ADDENDUM NO. 5

DATE: April 3, 2020

PROJECT: ITB 20343
BETHUNE POINT WATER RECLAMATION FACILITY
GENERATOR REPLACEMENT

C-101
Sheet

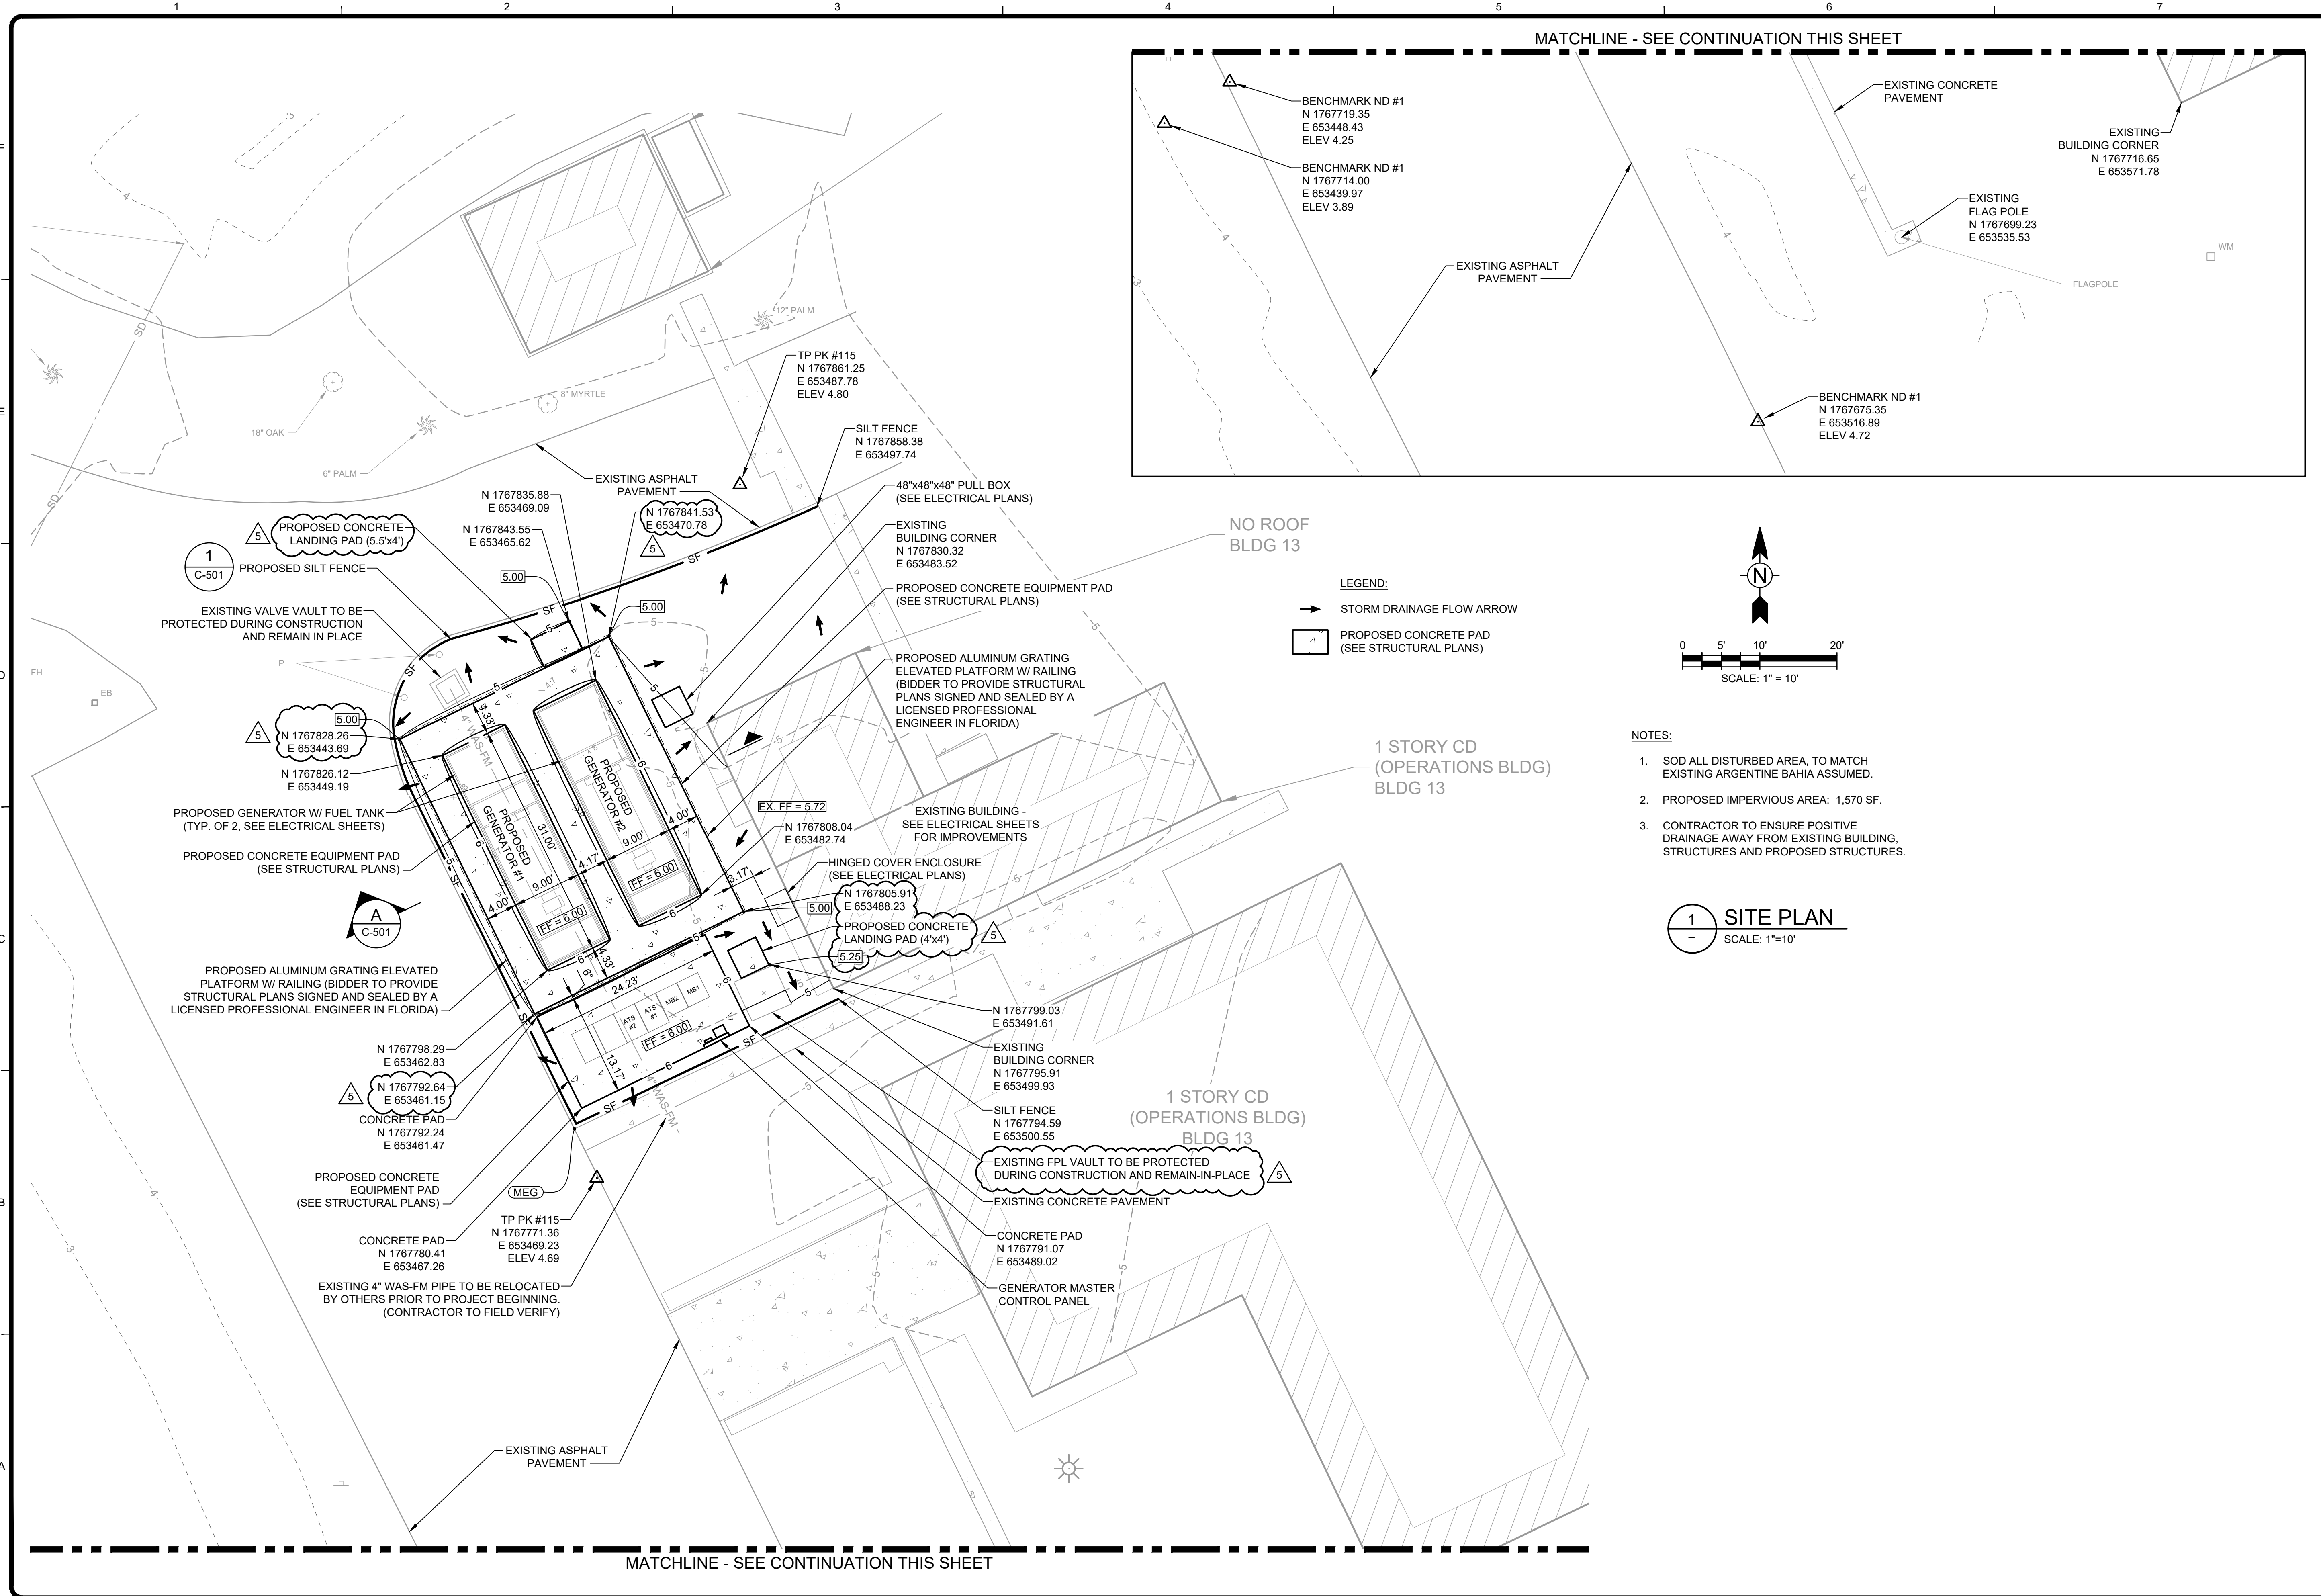
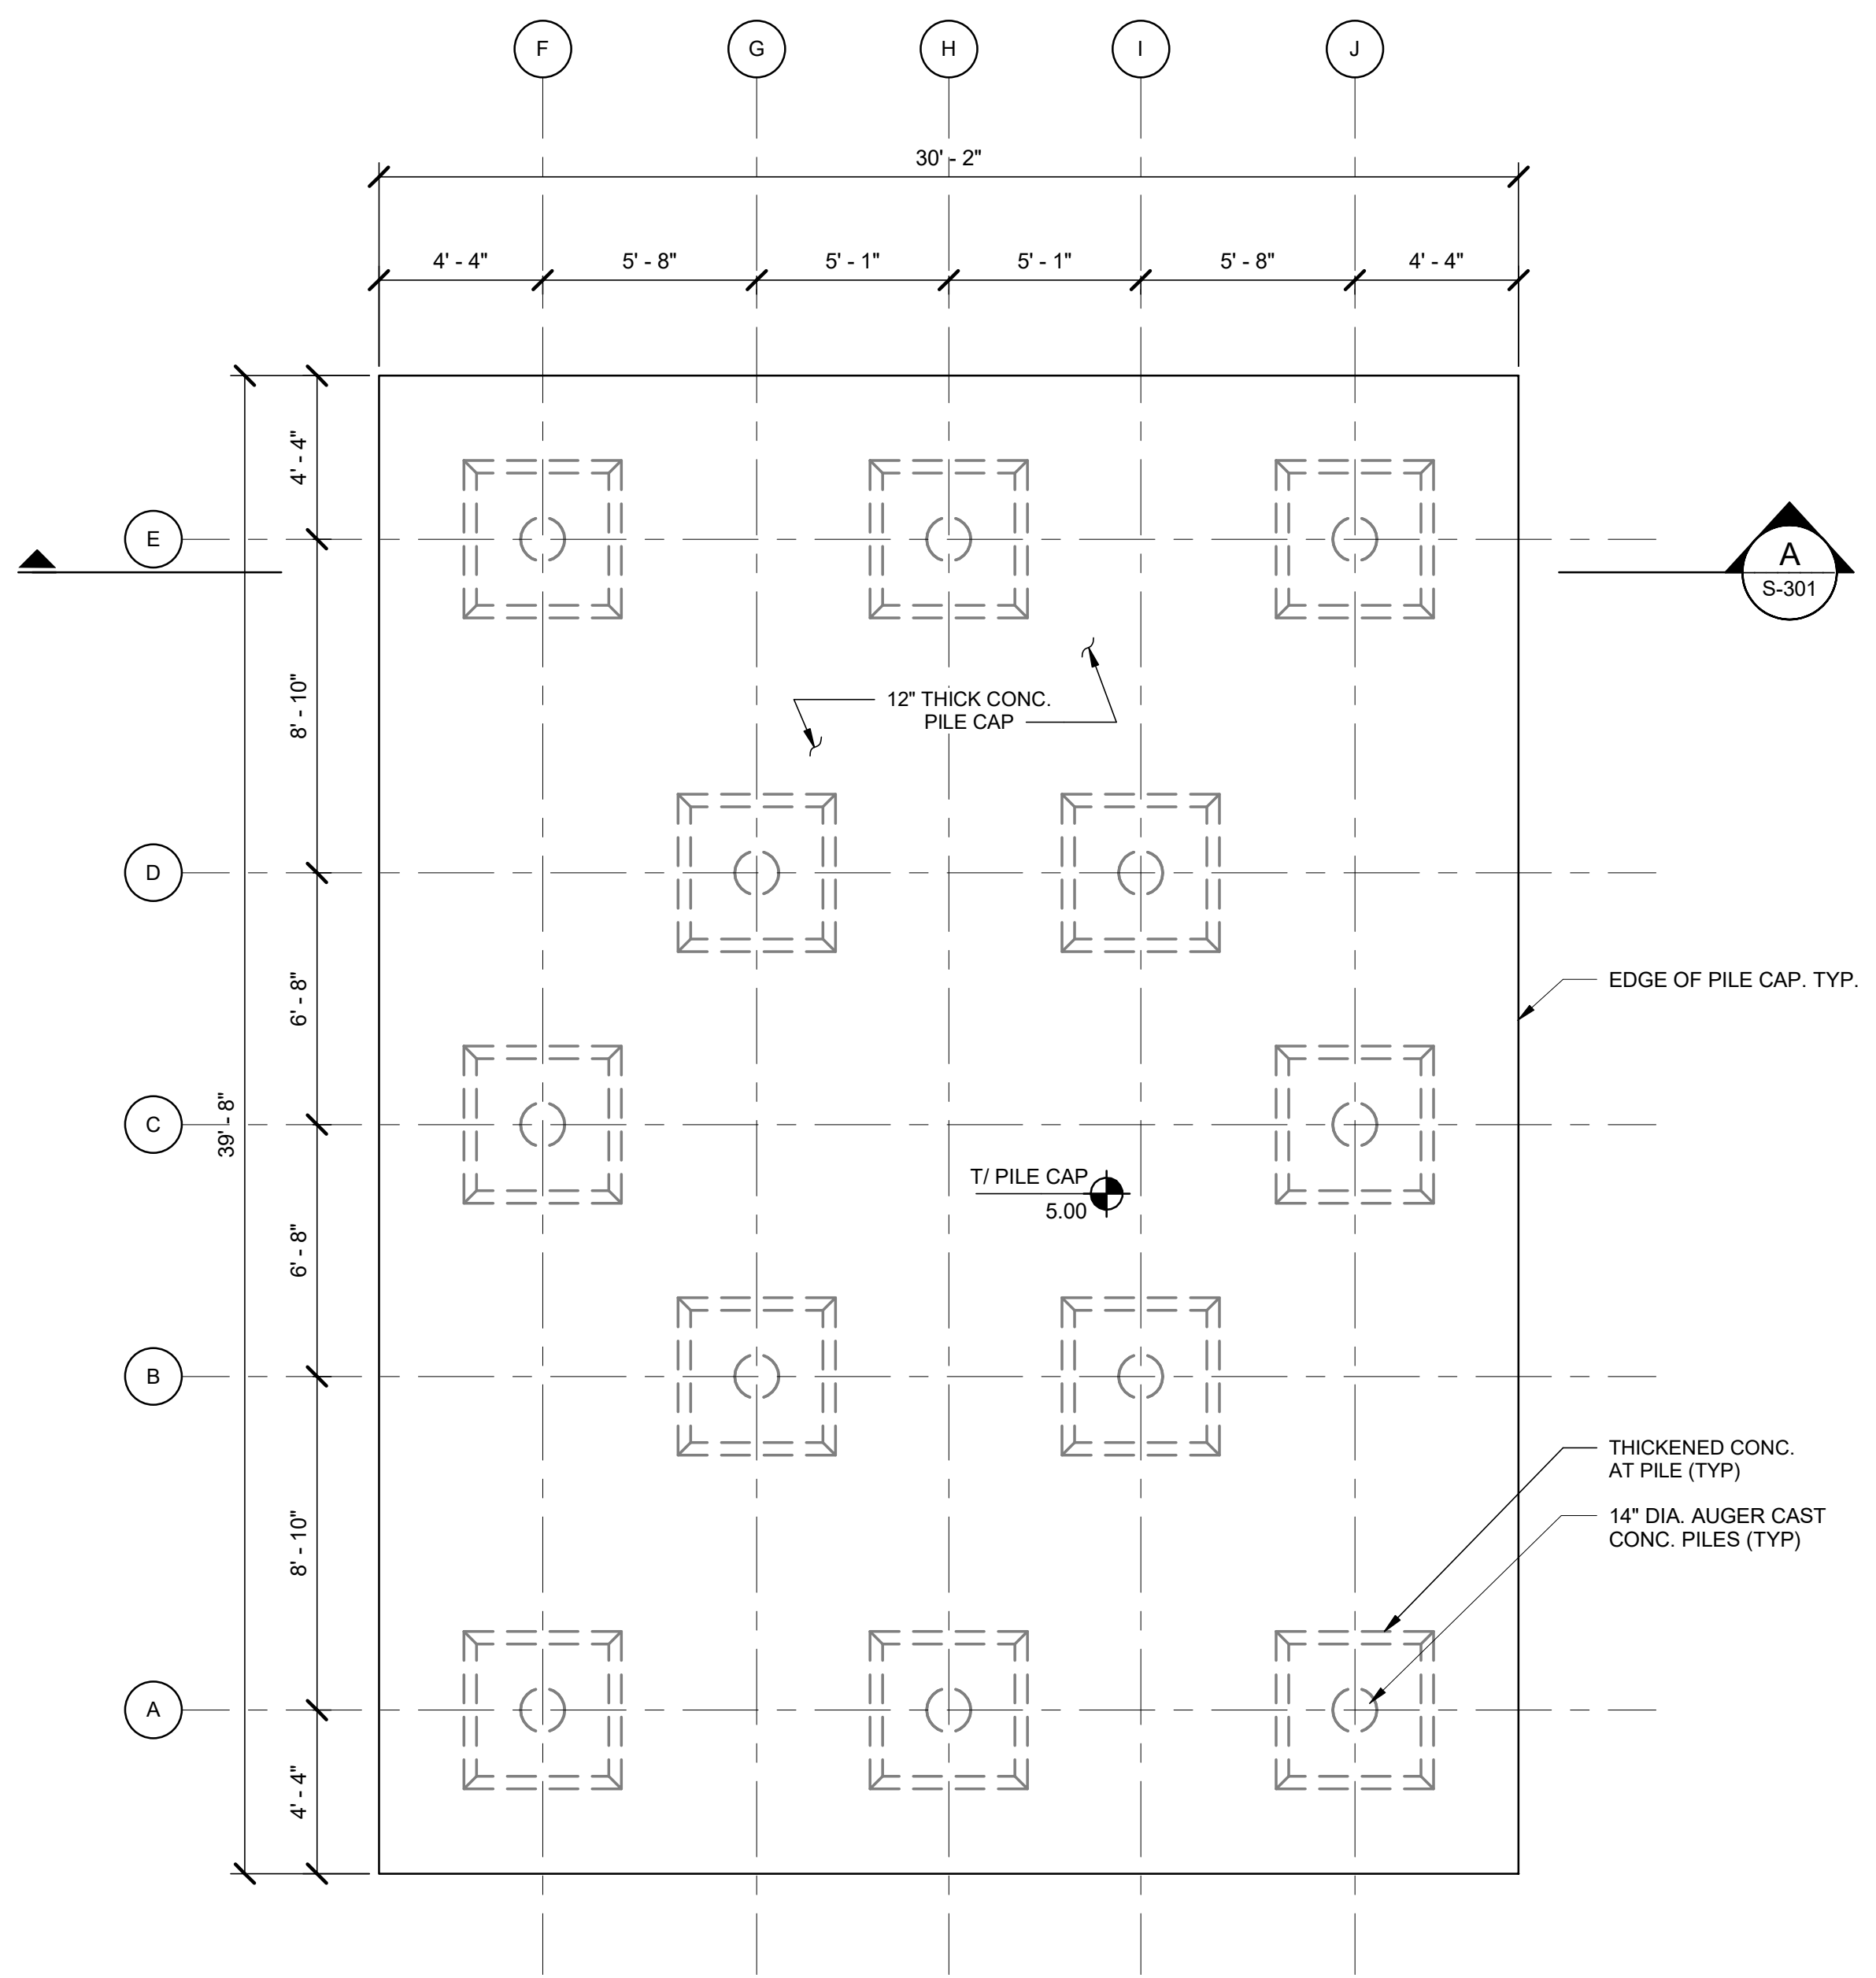
A. Please see revised Sheet C-101 attached. Revisions are highlighted by clouds.
